T. PRESTON GILLESPIE, Jr.
Vice President
Oconee Nuclear Station

Subject: Duke Energy Carolinas, LLC
Oconee Nuclear Station, Units 1, 2, and 3
Docket Numbers 50-269, 50-270, and 50-287,
Renewed Operating Licenses DPR-38, DPR-47, and DPR-55
Tornado and High Energy Line Break (HELB) Mitigation License Amendment
Requests (LARs) - Supplemental Responses to Request for Additional
Information (RAI) Nos. 61, 62, and 107

Supplemental Responses to RAI Nos. 61, 62, and 107

RAI 61 HELB Event Overview

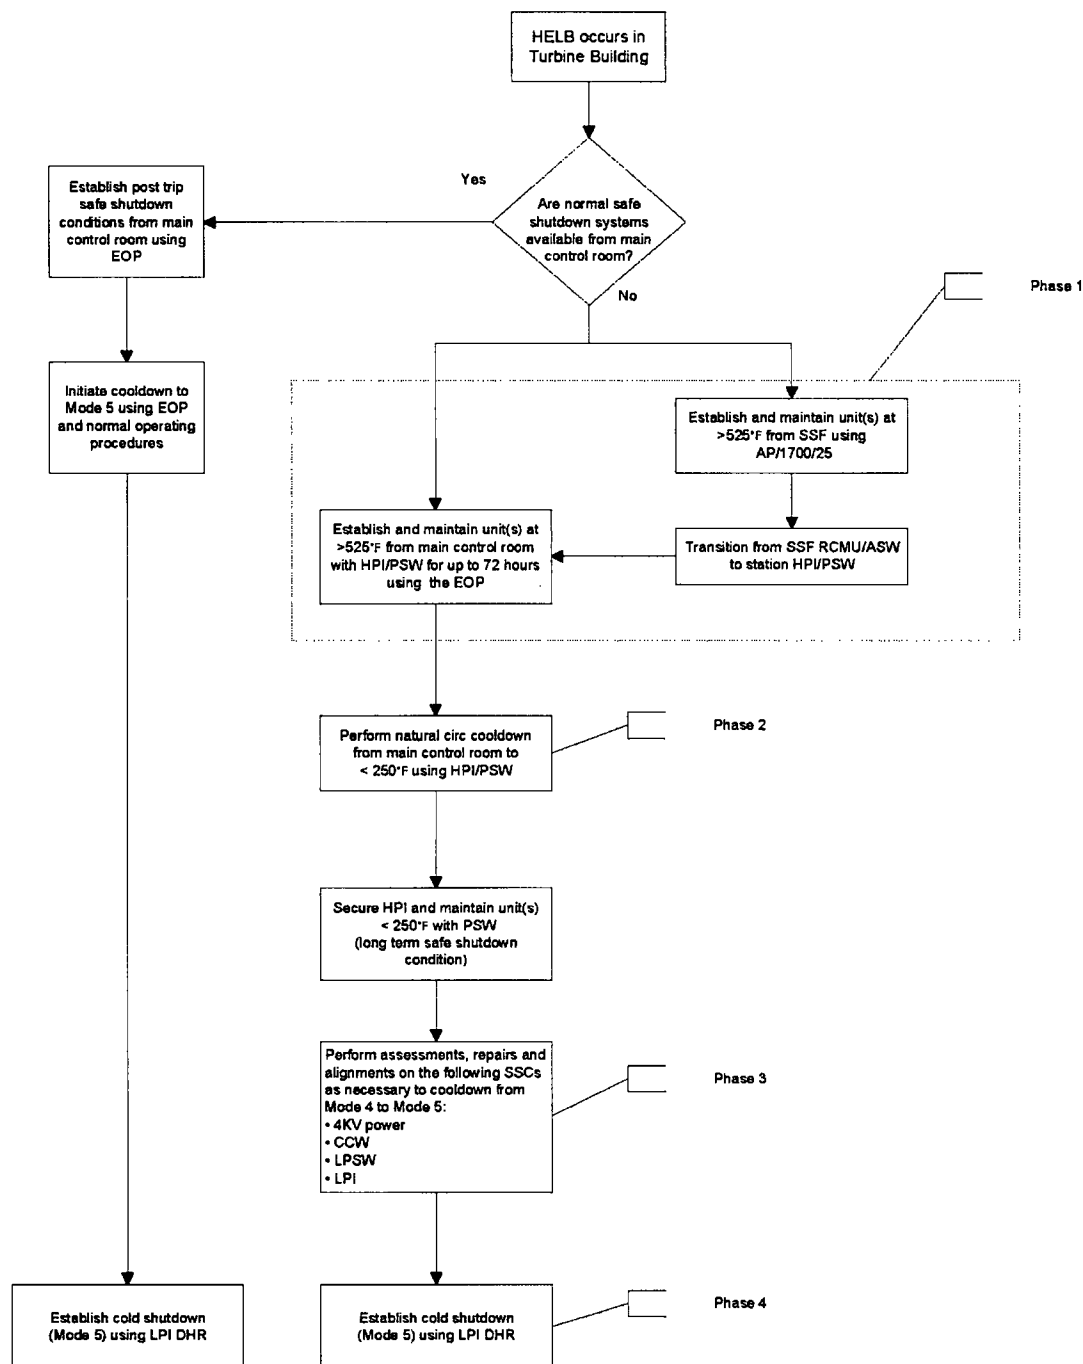
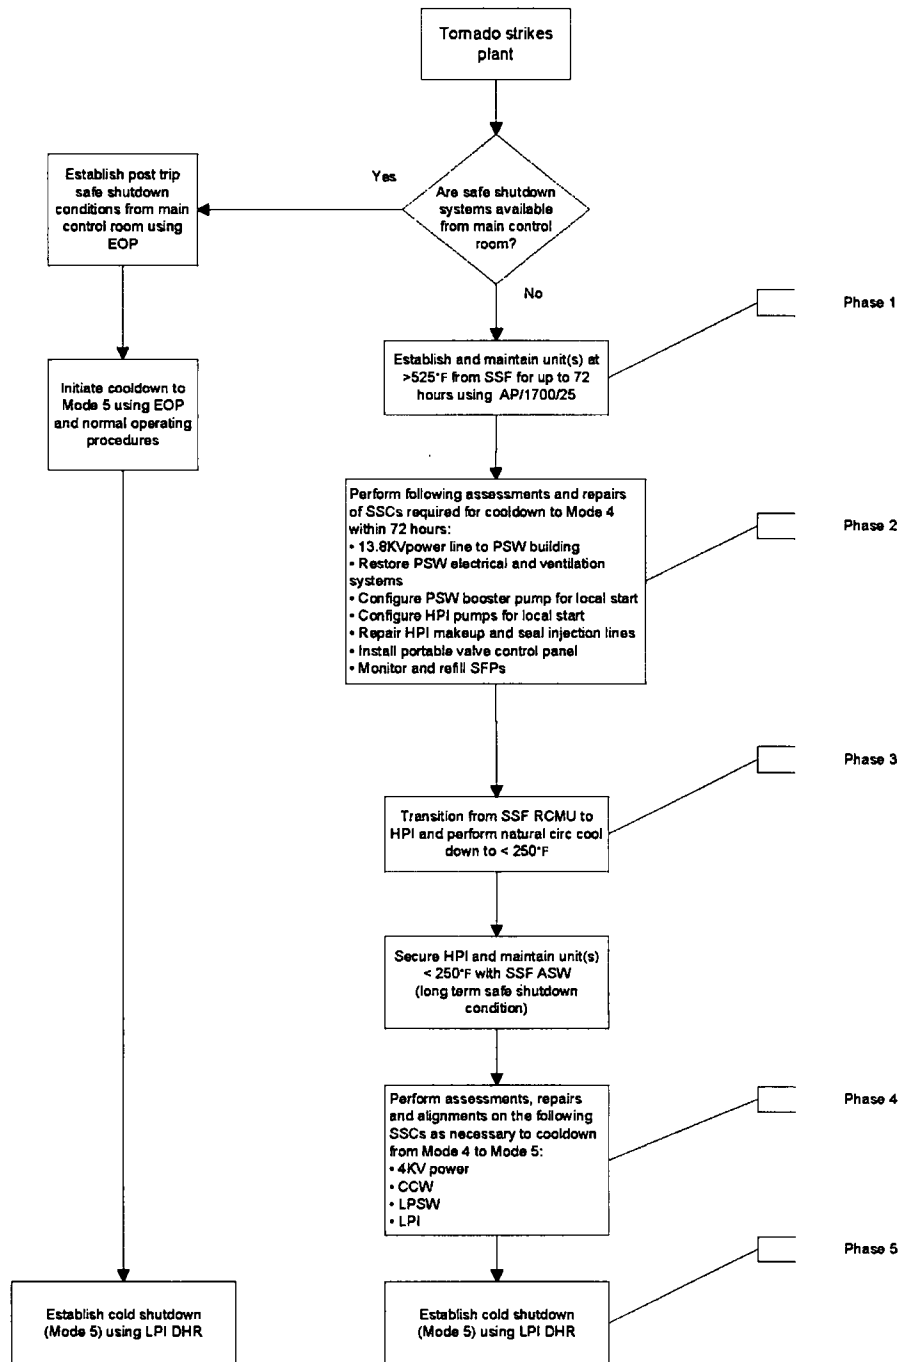
Provide a complete event sequence following a tornado and/or an HELB. In your response, provide a summary of the sequence of actions required for achieving each phase of the mitigating strategies showing how MODES of operation 3, 4, and 5 as defined in Table 1.1-1 of your Technical Specifications (TSs) will be achieved. Identify all equipment that will be available following the events to mitigate a tornado and/or an HELB. Identify all required operator actions, and when each operator action has to be completed. Identify all required repairs, and when they must be completed. For any necessary repairs provide the actions required, manpower required, and all equipment and parts that are necessary to complete the repairs. Demonstrate that the sequence of events would not result in unacceptable radiological consequences. Identify and justify the selected acceptance criteria (fission product barriers are maintained, and the spent fuel remains within the licensing basis). Provide a detailed description of the analyses performed to support the conclusions.

Refer to enclosed flowchart for overview of mitigation strategy addressed in this response.

Refer to enclosed flowchart for overview of mitigation strategy addressed in this response.
